#### ADDENDUM NO. 1

PROJECT: S&C # P160218; Stoddard County Road 488 Bridge

#### **SUBJECT: Project Manual Changes/Clarifications**

#### **SUBJECT: Project Plans Changes/Clarifications**

**TYPICAL ELEVATION AT CROSSING ALONG ROAD CL.**

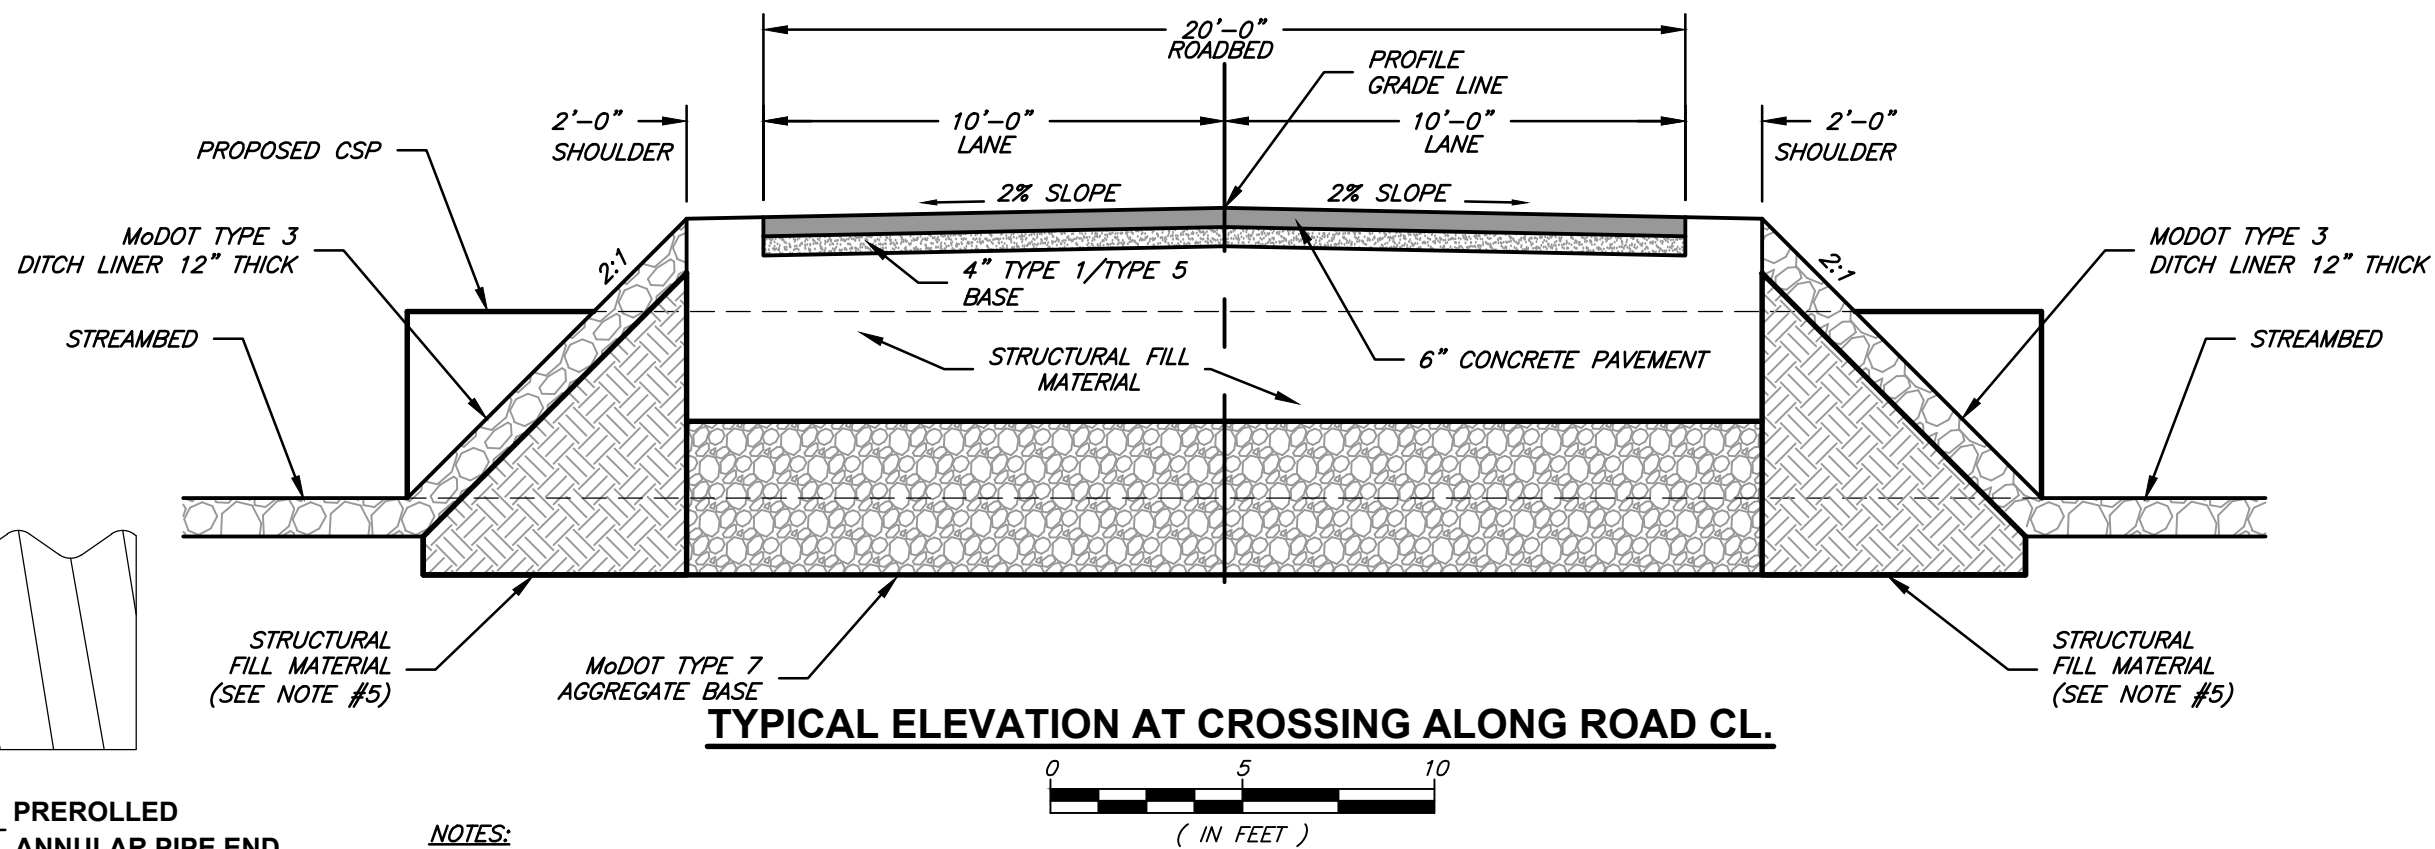
1. Sheet 4 – ARCH PIPE DETAILS AND LAYOUT
  - An additional detail was provided for the road details regarding the alternate paving. See attached sheet 4 and 4.1 for clarification.
